Subject: Sanford WFF Expansion Progress and 60% Design Review Meeting

This meeting was held to review the progress and 60% design submittal for the Sanford Water Treatment Plant Expansion Project.

Conventional Treatment No. 1 – Alternative Flow Paths

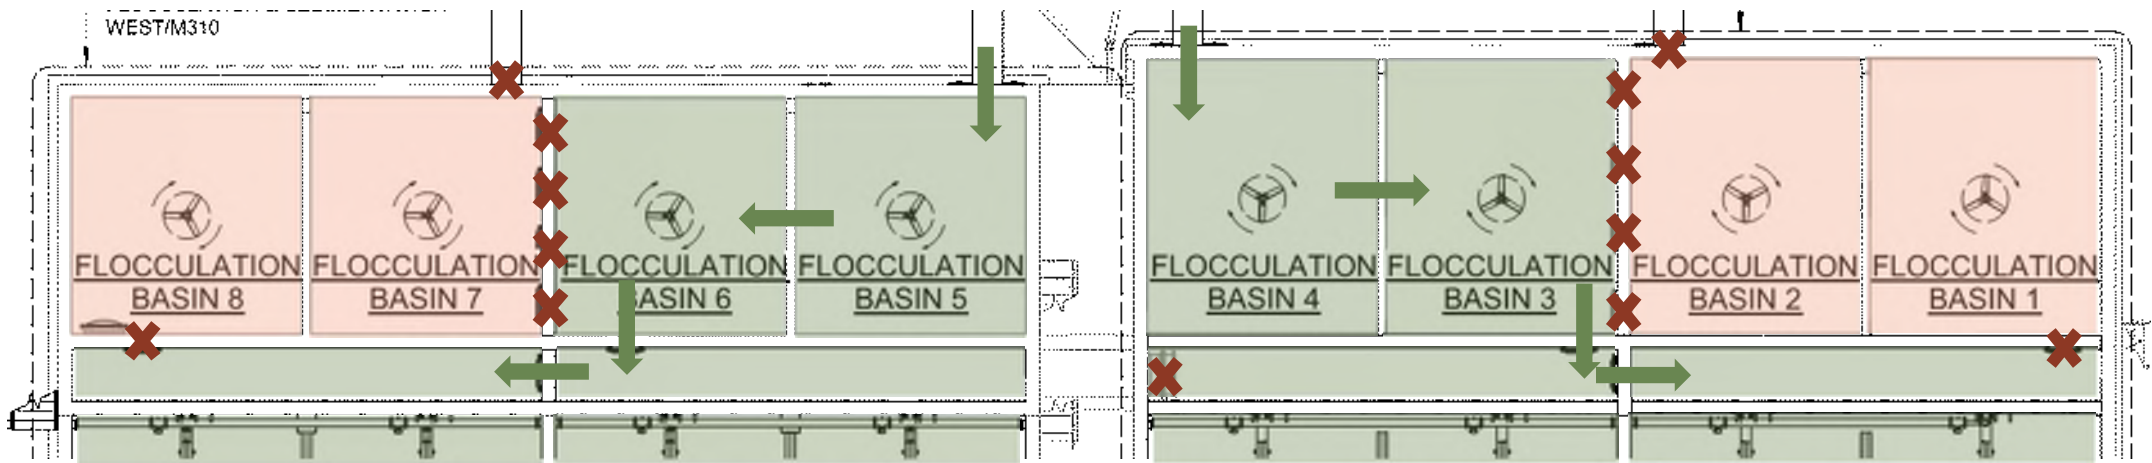
[@Gibson, Sara] - typ of all these sheets, I showed the 48" BFV between Sed Basins 2 and 3 as normally closed. Let me know if you disagree

Conventional Treatment No. 1 – Maintenance Access and NPW Hydrant Locations?

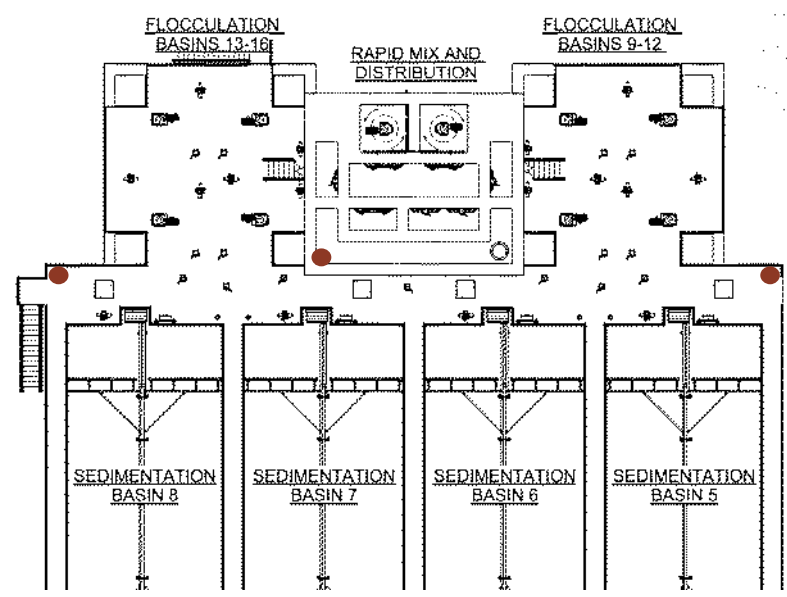
- Sanford currently has two NPW hydrants near the filters and must drop a ladder down into a basin for access.
 - If feasible with this project, Sanford would like additional hydrants close to each basin and filter.

- Provide a stainless steel fixed ladder in each existing sed basin.
 - Conventional Treatment Facility 2
 - Sanford would prefer more open space over each floc basin for visibility purposes.

- Provide hydrants between each set of 2 filters and 2 basins.
 - Provide a stainless steel fixed ladder in each new sed basin.
- Plate Settler Covers
 - Hazen reviewed plate settler cover options, including limitations between plate settler manufacturers and cost-prohibitive structures.

Plate Settler - Covers

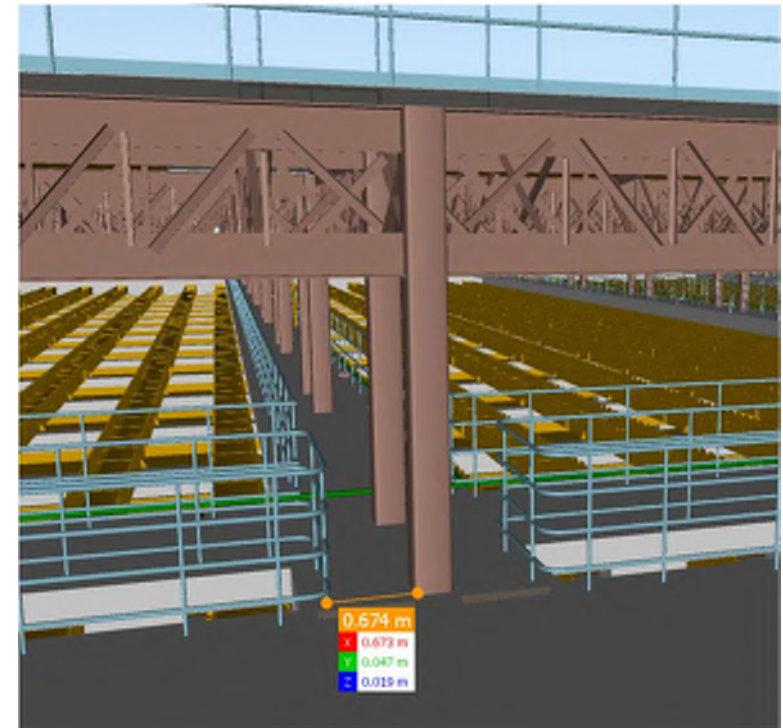
- The working cost estimate includes MRI plate settler covers which are closed-cell foam wrapped in stainless steel.
 - Hazen's current recommendation is to bid MRI and JMS with an alternative bid deduct for providing JMS plate settlers without covers. Hazen will continue to explore if there are other options.

- Sanford inquired if any automatic washing systems over plates exist. Hazen is not aware of any.

One Truck Scale

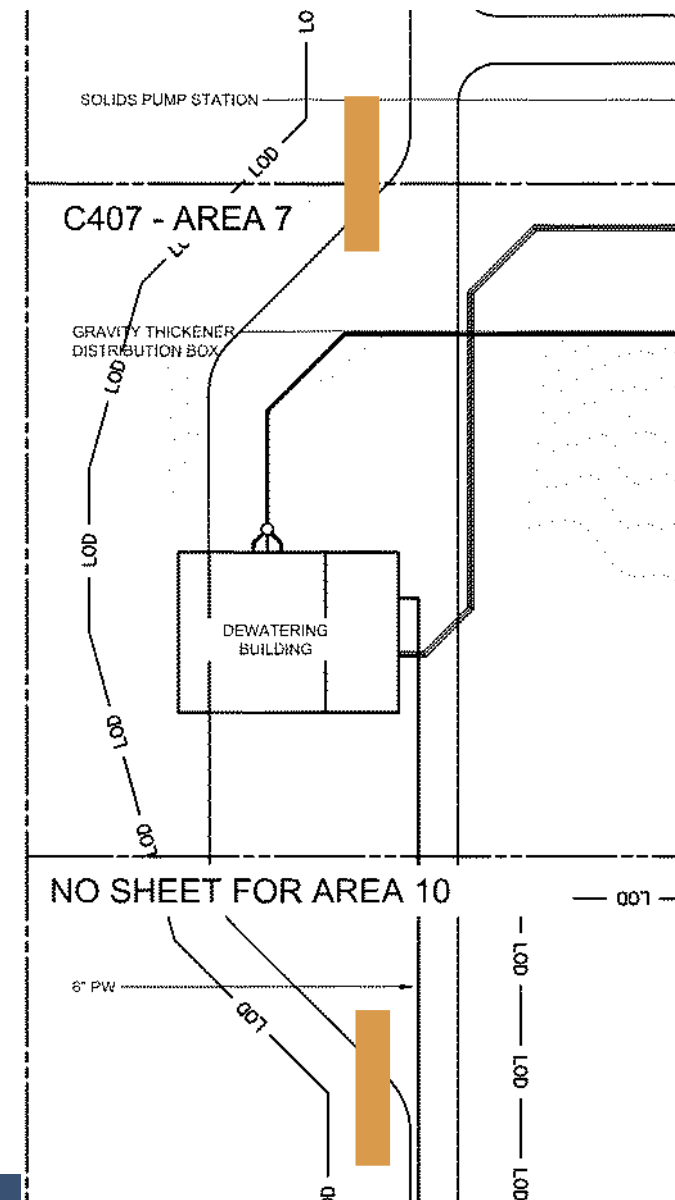
- Scales
 - Paul Weeks inquired about the fee for an overweight ticket. Hazen will investigate but initial research indicated ~\$100 to \$500 per event (**Hazen Action Item**).

- Sanford requested a cost analysis comparing scale installation and overweight ticket payments (**Hazen Action Item**).
- Chris Brinkley inquired about where potable water line was coming from. This is being reviewed internally.

Filter Gallery Access Option 2

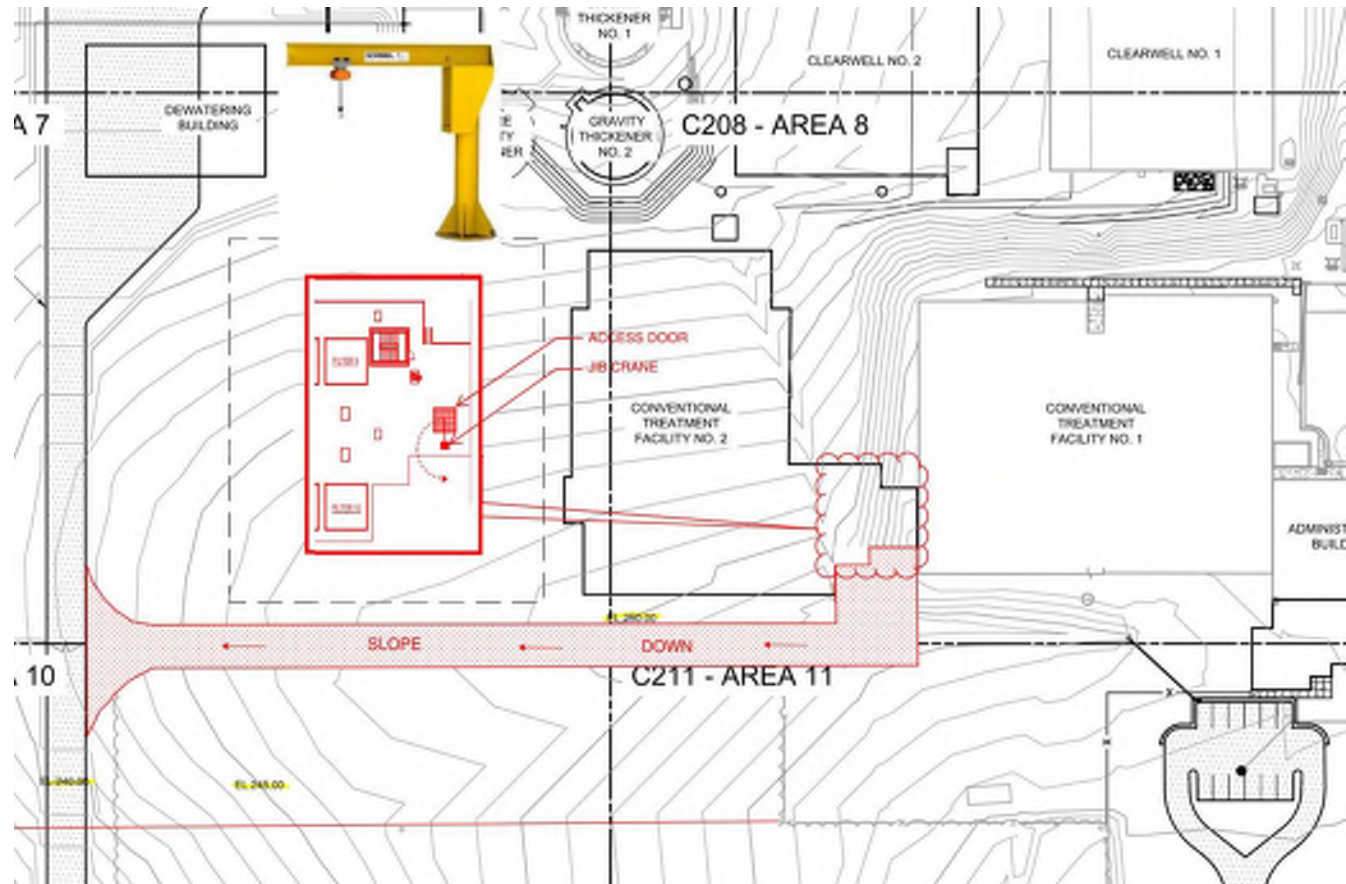
- Sanford requested that the filter influent BFV actuators be located above grade for accessibility.
- Filter Gallery access options were discussed.
 - Sanford would use this for routine maintenance in addition to equipment removal / installation.

- The Sunbelt scissor lift is likely the heaviest item to be transported.
 - Sanford would like for the access hatch to be symmetrical.
 - Sanford would like to see a high-level cost breakdown prior to making a decision (**Hazen Action Item**).

Plan View of 1959 Wet Well

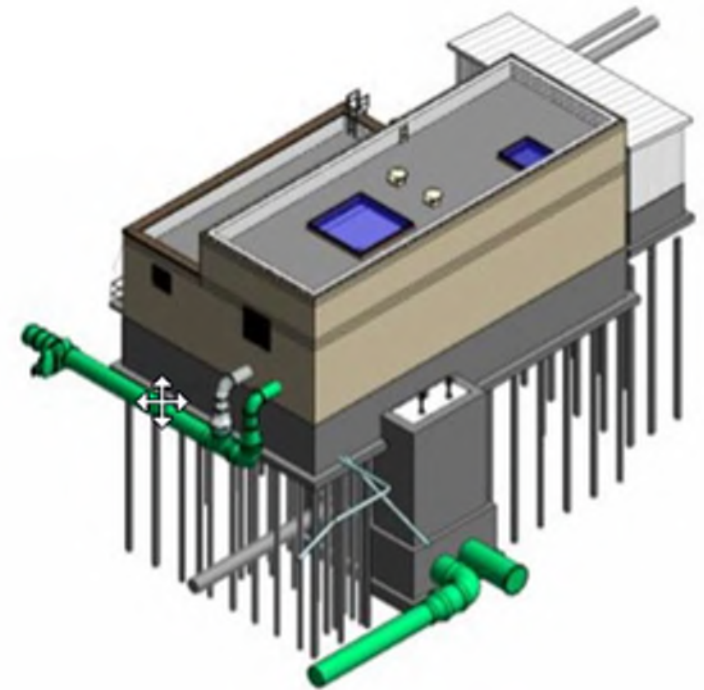
Cory recommending a slide for structural [@Turner, Daniel] [@Bobier, Laura]

4. New Station (West of Existing Station)

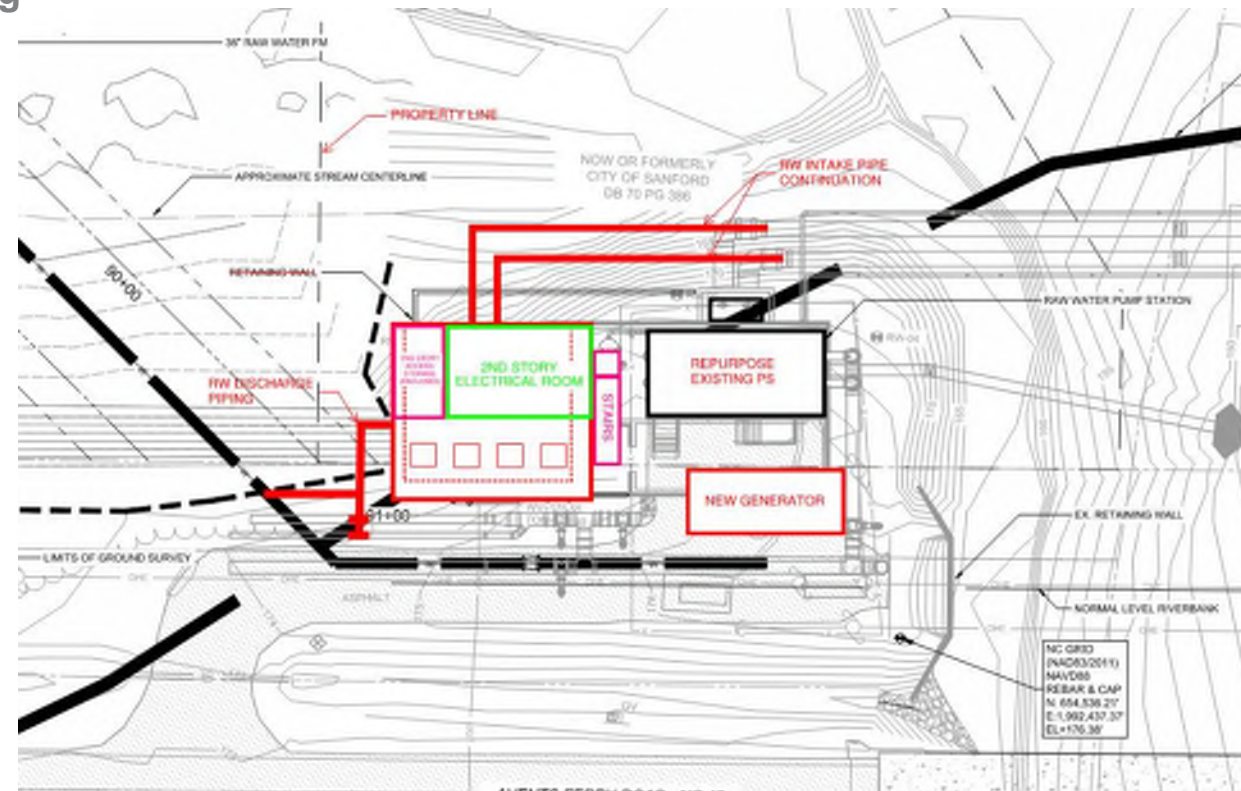
- Sanford indicated a preference for Concept #4 but will discuss internally. *Note: After the meeting, Sanford sent an email to Hazen on September 14th confirming the decision to move forward with Concept #4.*

Slide 84

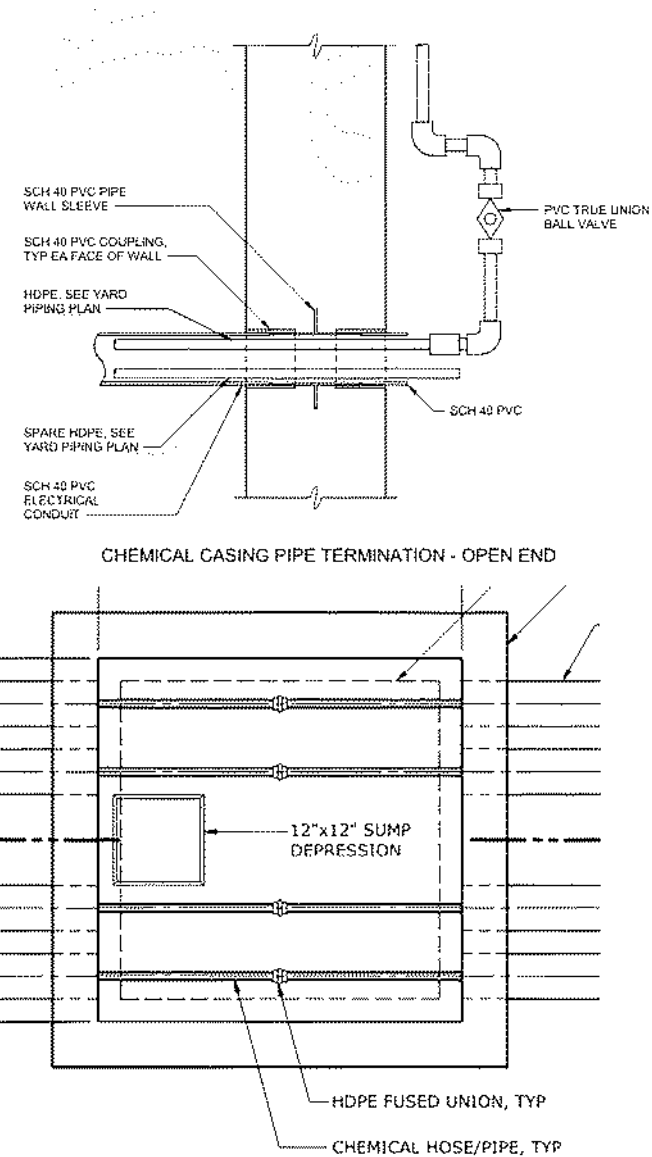
- TK0 0** fyi - this is shown on the E vault drawings sheets.
Thompson, Kyle, 2022-09-12T18:11:35.371
- GM1** Sanford expressed a preference for a permanently installed sump pump in each vault. Options will be explored for the sump pumps to automatically pump or be manually pumped. A high level alarm may be installed to alarm the plant to investigate what is in the vault prior to determining where to pump contents. A high-high level switch will be installed to alarm the operator to go investigate in the event of a pump failure and rising fluid levels in the vault.
Sanford would like the ability to route the sump pumps to a common drain (when it is wash down water / rainwater and not chemicals). Hazen will investigate routing this to the backwash EQ tank, or something similar.
Guillou, Maggie, 2022-09-07T20:02:05.899

- GM2** was this detail taken out of latest drawing set?
Guillou, Maggie, 2022-09-08T18:28:59.045
- TK2 0** yes - it was replaced with M-40-0116R when decided to run parallel piping through the casing. I would replace this with the new detail. See sheet MD02
Thompson, Kyle, 2022-09-12T18:10:19.306

- GM2 1** [@Thompson, Kyle] replaced graphic
Guillou, Maggie, 2022-09-12T20:07:15.388
- TK3** I would show a plan view of this in the slideshow since this is new. Can talk about the connections being specified here.
Thompson, Kyle, 2022-09-12T18:12:06.966

Sampling and Pumps

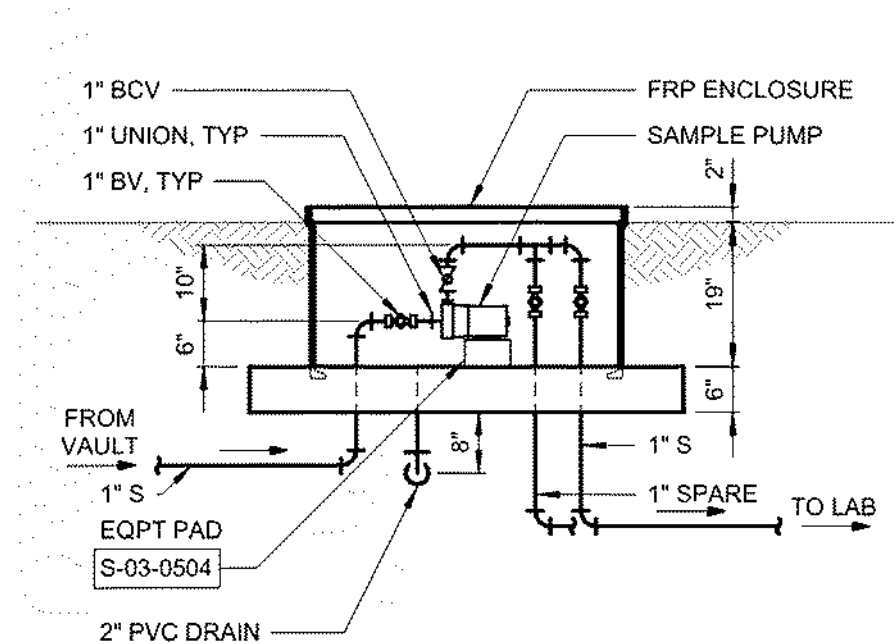
- Samples and Pumps
 - Design currently does not provide heat tracing or insulation in sample pump boxes.
 - Brian Keas expressed concern with the sample pump boxes filling with rain or groundwater. Preference is to utilize an FRP enclosure at grade similar to what is on top of the Finished Water Chemical Vault (**Hazen Action Item**).

- Would need to add heat tracing or insulation to the design.

- Hazen to explore other options for locating sample pumps on a concrete pad on top of vaults or at grade.
- Sanford prefers a hot box with hinged access for these pumps.
- Sanford prefers the Grundfos SCALA pumps if there is flooded suction, but it does not work well when suction lift is required. AMT pumps do not have capacity for suction lift either.
 - Operators prefer to have the least expensive option for sample pumps that can be replaced annually.
 - Hazen will explore additional alternatives for sample pumps (**Hazen Action Item**).
- Most analyzers are currently in the lab (turbidity analyzers are located in the basement) but Sanford is open to them being closer to the sample location. Hazen confirmed all analyzers will have feedback to SCADA.
